**No.2 Figtree
Drive, Sydney
Olympic Park
Design
Changes**

State Significant
Development
Modification Assessment
(SSD 7662 MOD 2)

March 2019

Figure 9 | Approved Apartment 50101 (left) and proposed conversion into leasing office (right)
(Source: BVN)

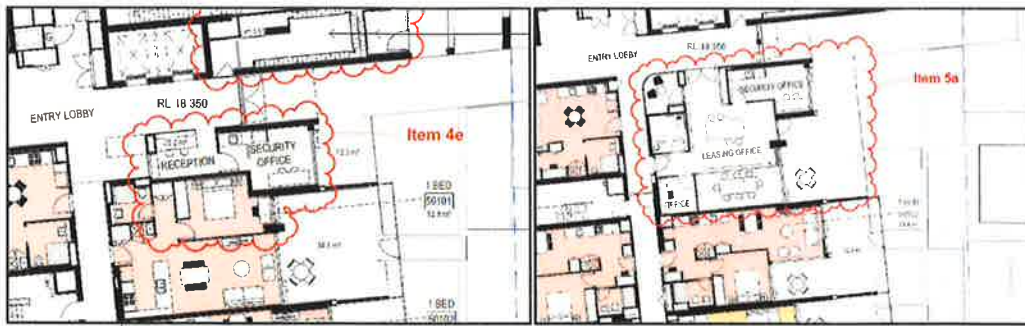
- The proposal seeks to convert Apartment 50101 into a leasing office to facilitate the administration of the apartment sales. The leasing office would be located adjacent to the approved security office and reception space and is shown at **Figure 9**.
- The Department notes that no internal works are required to complete the conversion or vice versa. The Applicant has provided approved, temporary and proposed yield schedules with the RtS report.
- The Department does not consider the leasing office would result in any adverse environmental impacts and would not affect the residential amenity of the site.
- The Department therefore concludes the proposed conversion of Apartment 50101 into a leasing office is acceptable.
- No additional conditions or amendments are necessary

Figure 10 | Convert Apartment 50108 on the ground floor of Building 5 into a temporary display suite
(Source: BVN)

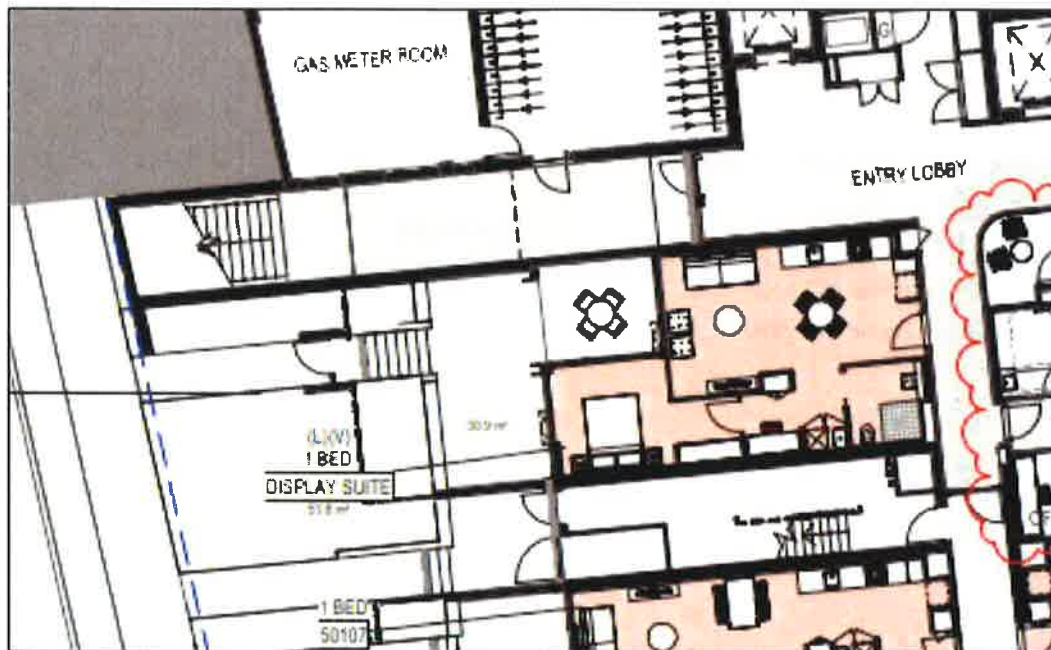
- The modification seeks to convert a ground floor, one-bedroom apartment (Apartment 50108) into a temporary display suite.
- In the RtS report, the Applicant noted the temporary arrangement is intended to operate until all apartments have been sold. This is anticipated to take six to 12 months. The proposed temporary arrangement has been incorporated in the unit mix calculations and the Applicant has provided residential yield tables relating to the approved (698), temporary (695) and proposed final (696) development schemes.
- The Department considers the proposed change is minor, temporary and would not result in any adverse impacts at the site. The Department therefore concludes the conversion of the apartment into a temporary display suite to be acceptable.
- No additional conditions or amendments are necessary

Figure 11 | Identify apartment 20301 (left) as an adaptable unit and 52311 (right) as a liveable unit (Source: BVN)

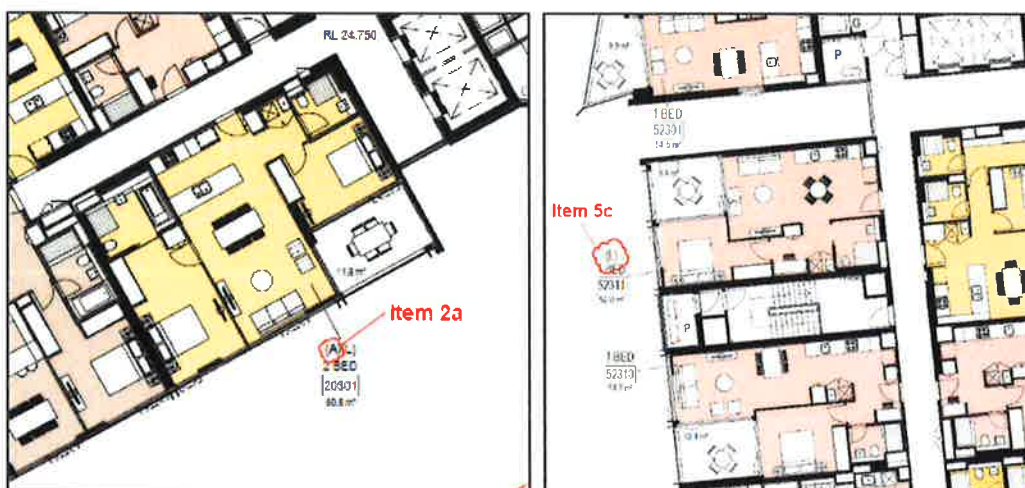
| <p>Identification of adaptable apartments and liveable apartment</p> | <ul style="list-style-type: none"> • In addition to the above changes to the unit mix, the modification application seeks to identify Apartment 20301 as an adaptable apartment and Apartment 52311 as a liveable unit (Figure 11). No change is proposed to either apartment's type, size or layout. • The Department notes the proposed identification of the two apartments and does not consider it would give rise to any environmental impacts. • The Department therefore concludes this element of the modification application is acceptable. | <ul style="list-style-type: none"> • No additional conditions or amendments are necessary |

Figure 12 | The proposed sky bridge as viewed from the western elevation (Source: BVN)

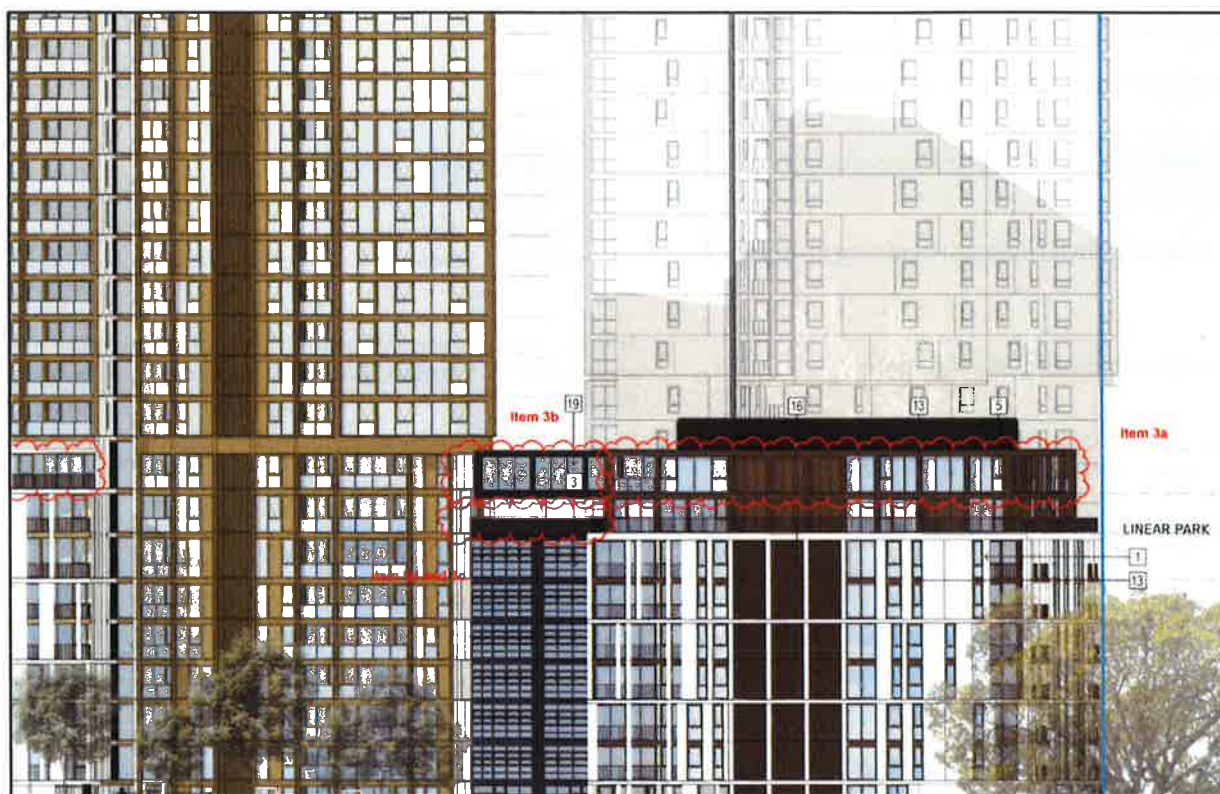
The Department did not receive any submissions in relation to the sky bridge and consider the new access between Building 3 and Building 5 would ensure that residents in both buildings will have equal access to the indoor communal space. The Department does not consider the proposed sky bridge would have any adverse overshadowing or visual impacts and is therefore acceptable.

As pictured in **Figure 12**, the design of the proposed sky bridge would suitably integrate with the style of the broader development. The sky bridge would be constructed of similar materials and finishes, spaces windows consistently with other aspects of the development and maintain a consistent ceiling height with level 9 of Building 3. The sky bridge has been designed to be visually recessive and would not add significant massing to the buildings at the site.

The Applicant provided shadow analysis to assess the impact of the proposed change. The analysis demonstrated that due to the scale and location of the proposed sky bridge, it would not result in any additional overshadowing at the site beyond what was approved under SSD 7662. The property at 4 Figtree Drive will continue to be partially overshadowed during the morning of the winter solstice despite the majority of the overshadowing falling to the south across Sarah Durack Avenue during the day.

Figure 13 | The proposed layout and patron capacity of the indoor communal area (Source: BVN)

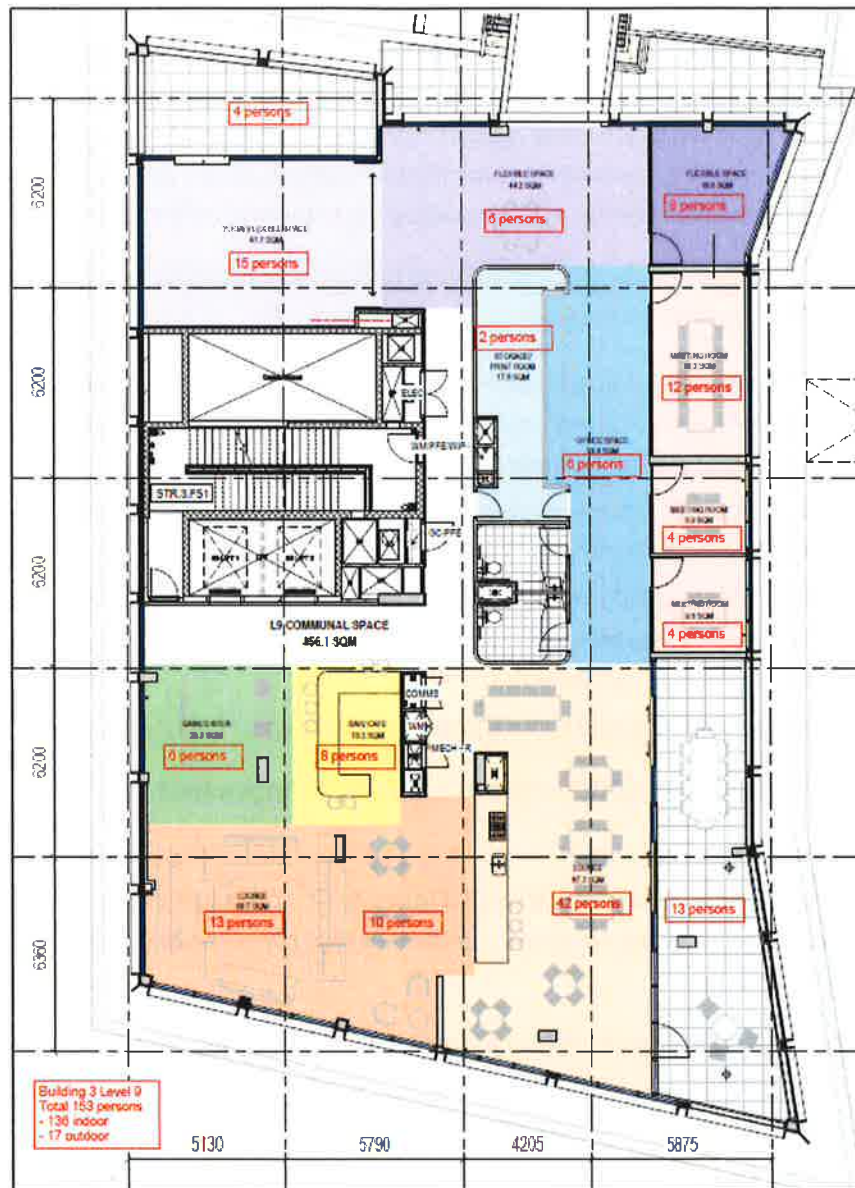
The Department notes the modification application seeks a maximum capacity of 153 people (136 indoor and 17 outdoor). This represents an increase of 71 people (86.5% increase) from the maximum capacity approved for the communal indoor space approved under SSD 7662 MOD 1.

To facilitate the operation of the indoor communal area without adversely impacting adjoining residents, the Department recommends conditions of consent requiring further acoustic analysis during the design development phase, once materials and finishes have been confirmed. A condition of consent has been recommended to require a noise management plan be implemented to demonstrate compliance with the acoustic report prior to the occupation of the building.

The Department considers the potential acoustic impacts arising from the relocated and enlarged communal indoor space can be mitigated by the recommended conditions of consent and effective implementation of a noise management plan. The Department also considers the communal space provides a positive social benefit for the development and will contribute to the social cohesion and amenity of residents. The Department therefore concludes the proposed relocation and increase in size of the indoor communal space is acceptable.
